VIRGINIA ELECTRIC AND POWER COMPANY
RICHMOND, VIRGINIA 23261

VIRGINIA ELECTRIC AND POWER COMPANY
NORTH ANNA POWER STATION UNITS 1 AND 2
PROPOSED TECHNICAL SPECIFICATIONS CHANGES
ELIMINATION OF SEISMIC EFFECTS FROM CONTROL ROD DROP TIMES
REQUEST FOR ADDITIONAL INFORMATION

Response to Request for Additional Information
Elimination of Seismic Effects from Control Rod Drop Times

Figure 2.2

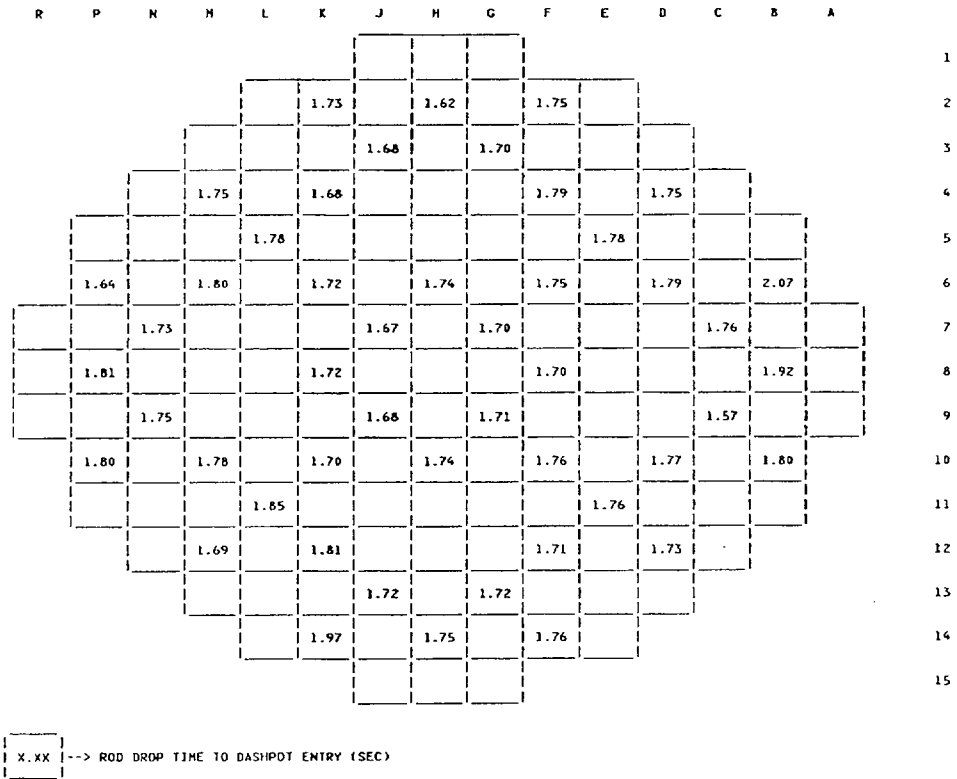
The submittal dated June 22, 2000 indicated that if accident analyses are re-performed, the rod drop time of 2.7 seconds would need to be increased. Such a change would involve concurrent reactor protection system changes (e.g., reductions in high pressurizer pressure and/or low RCS flow reactor trip setpoints). The submittal indicated this would have the potential to reduce normal operating margin and increase the potential for reactor trip events and associated plant equipment transients. Please discuss the potential magnitude of the decreases in the setpoints.

Current measured drop times provide slightly in excess of 0.5 second of margin to the 2.7 seconds Technical Specification limit (see attached Figure). However, much of this margin is currently allocated for the seismic allowance.

If the seismic penalty is not eliminated, Dominion estimates that the safety analysis rod drop time will have to be increased from 2.7 seconds to 3.2 seconds to ensure adequate margins for BOC startup tests.

T1: LOSS OF OFF-SITE POWER (LOOP)
 (96FEB = 1EP)

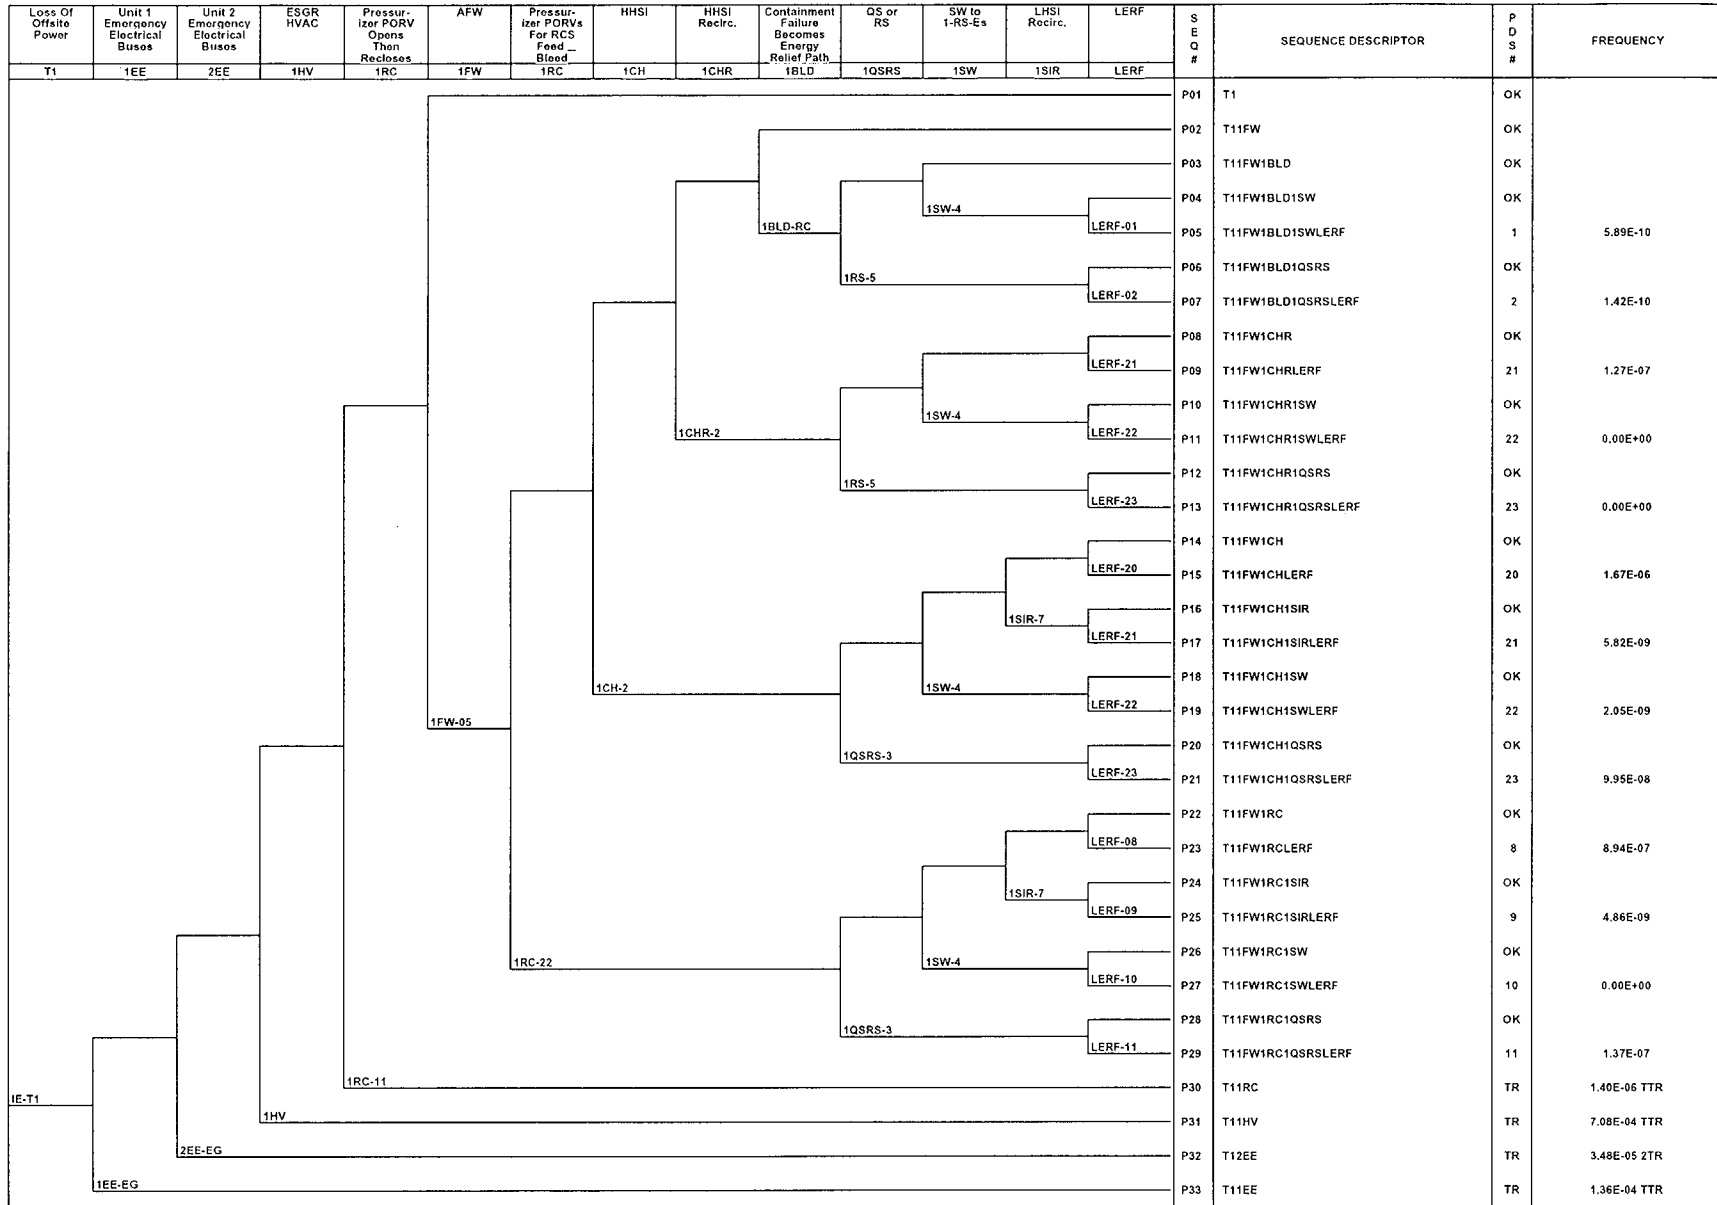
Please provide for review your seismic risk analysis of the failure of a turbine trip-reactor trip scenario mentioned in your July 26, 2001 submittal. Discuss the risk significance of this consideration using the guidance in R.G. 1.174.

The RCS integrity function, 1RC-11, in the enclosed event tree is the only failure for Sequence T1P30. The top fifty cut sets for this function are also enclosed. The top four cut sets from this list are those discussed in the meeting with the NRC staff in March 2001. As can be seen from the list even if one of the basic events was increased by a factor of 10 the result would still be several orders of magnitude below the dominant cut sets presented in the July 26, 2001 submittal (Attachment 4, page 9 of 10). That is, the dominant cut sets are on the order of $1\text{E-}2$ while the cut sets for failure of the PORV would be on the order of $1\text{E-}5$. The seismic sequence frequency is $3.3\text{E-}6/\text{year}$. This number includes the seismic convolution of the hazard and the fragility along with the random failures. The dominant random failures are going to continue to be in the $1\text{E-}2$ range so a change in the less dominant random cut sets from $1\text{E-}5$ to $1\text{E-}4$ is not going to increase the overall sequence frequency.
